DEVELOPMENT CONTROL COMMITTEE

19 OCTOBER 2023

AMENDMENT SHEET

Re: P/22/455/RLX Response to Officer's report dated 13/10/23

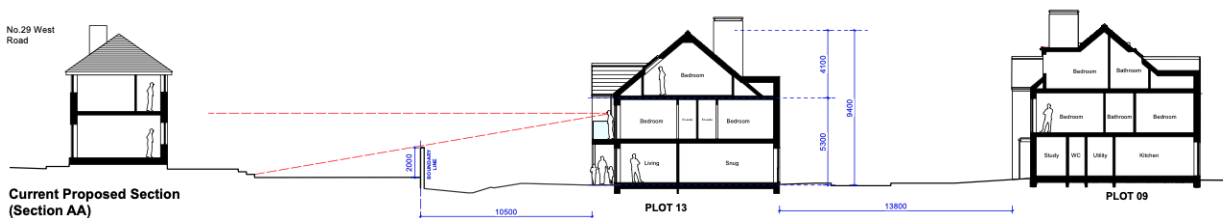
Officer: since the last Committee meeting amended plans have been submitted

SM: However the applicant's amended drawings are inadequate, and contain errors, to name but two:

- the tree shown does not exist
- the sightline from the balcony to the boundary is not shown

This is ludicrous when this was the reason for the deferral in the first place!

Residents section drawing from Draw Creative Design Ltd.

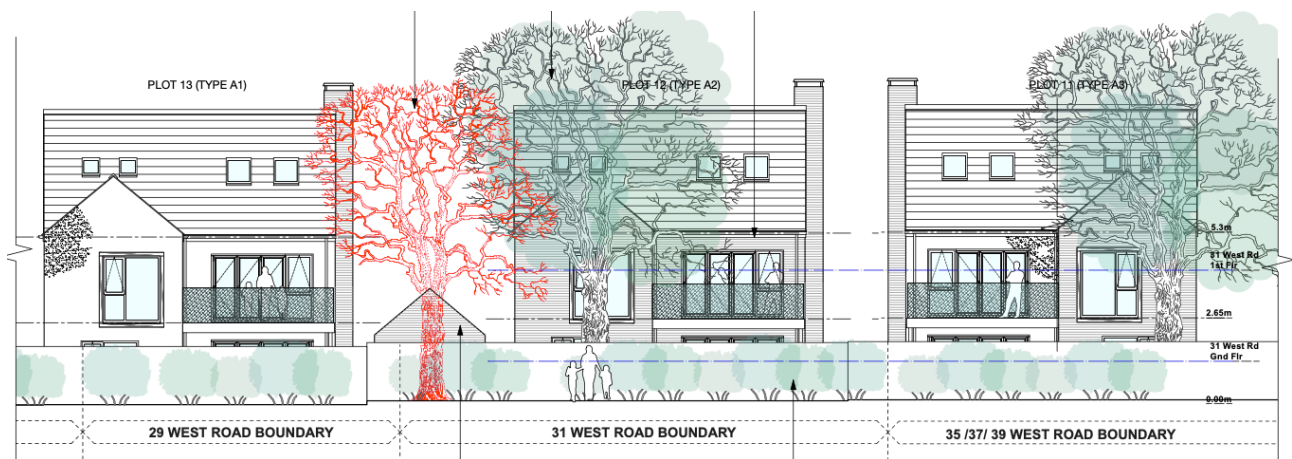
Collectively, residents have commissioned professional drawings to show an accurate section from plot 13 to 29 West Road. The sightline directly looking into the garden is obvious, especially when you consider there is no tree on the boundary.

Officer: the set back of plots is compliant with our SPG even if there were no trees on the boundary between proposed and existing properties;

SM: This is untrue.

The objection is the overlooking OF gardens, so the only relevant distance is NOT window to window, but window to boundary.

The SPG02 planning guideline requires:

- 10.5m for a first floor window to a boundary
- 12m for a first floor living space, which is what a balcony is

It is now compliant with SPG for a window, (which it fell far short of before) and as such is welcomed by West Road, but it is still not adequate for a balcony/living space which is 12m.

The officer's report ignores the 12m requirement entirely.
